ADDENDUM NUMBER: ONE

ISSUED BY: SEPW Architecture Inc.
109 – 3725 Pasqua St., Regina, SK. S4S 6W8
PH. (306) 569-2255

PROJECT: ROOF & FOUNDATION REMEDIATION

REGINA, SASKATCHEWAN

1 PARTIAL ROOF PLAN
A2.0 1:150

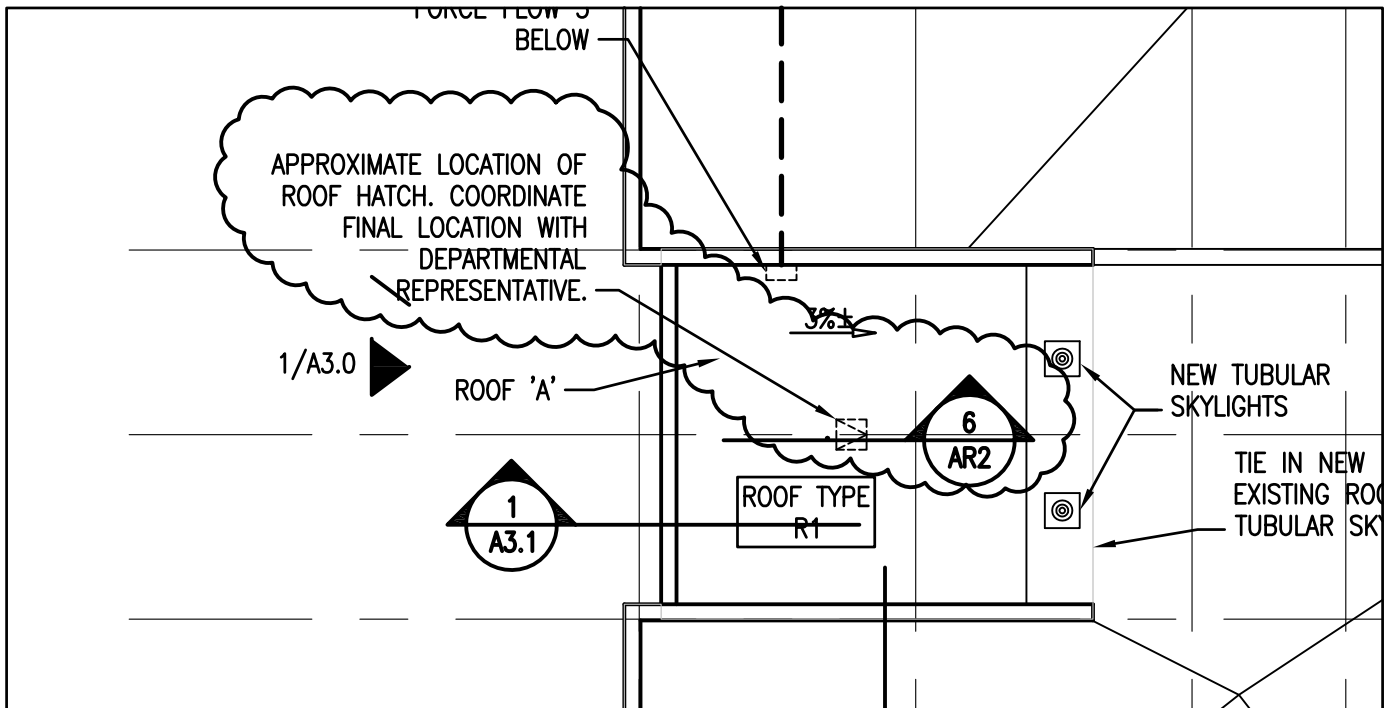
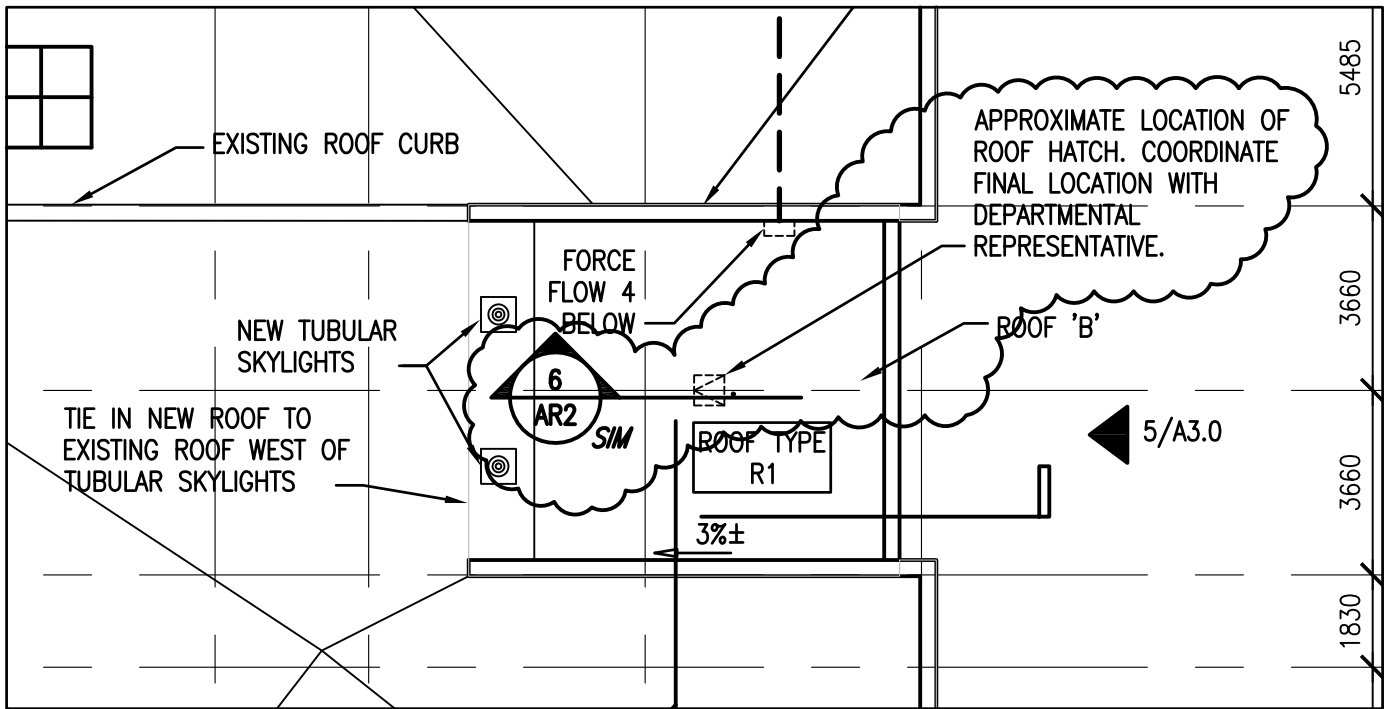
1. Add the following note: “Note: Access hatches associated with Roof ‘C’ and ‘D’ to be ¾ hour fire rated access hatches.”
2. Revise W2 wall type as follows: Replace 12.7 glass mat sheathing with 13 plywood sheathing.
3. Revise 1/A2.0 as indicated in attached sketch AR1.

DRAWING TITLE
ROOF HATCH SECTION DETAIL

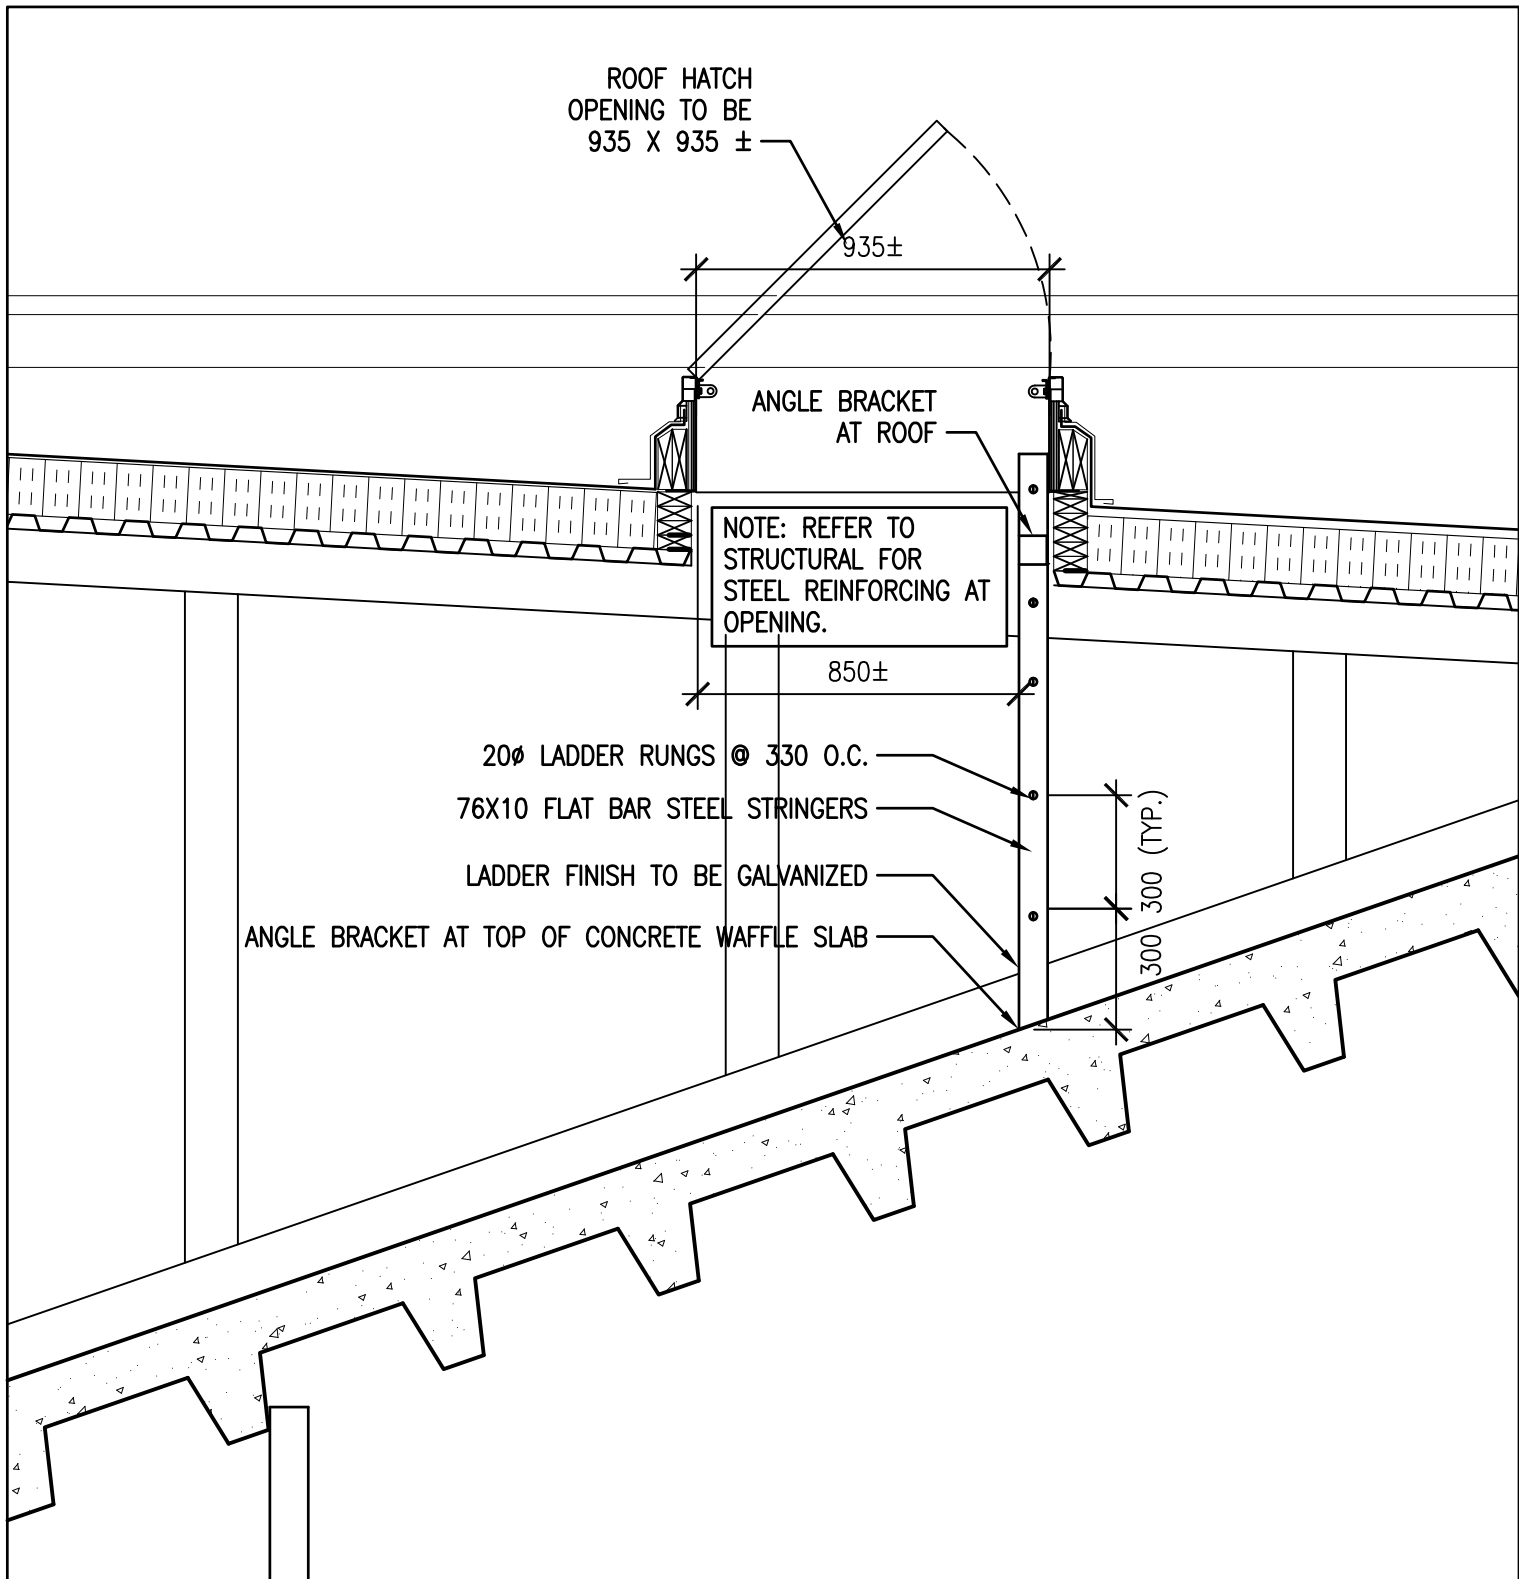
1. Add detail 6 on AR2 to A4.1.
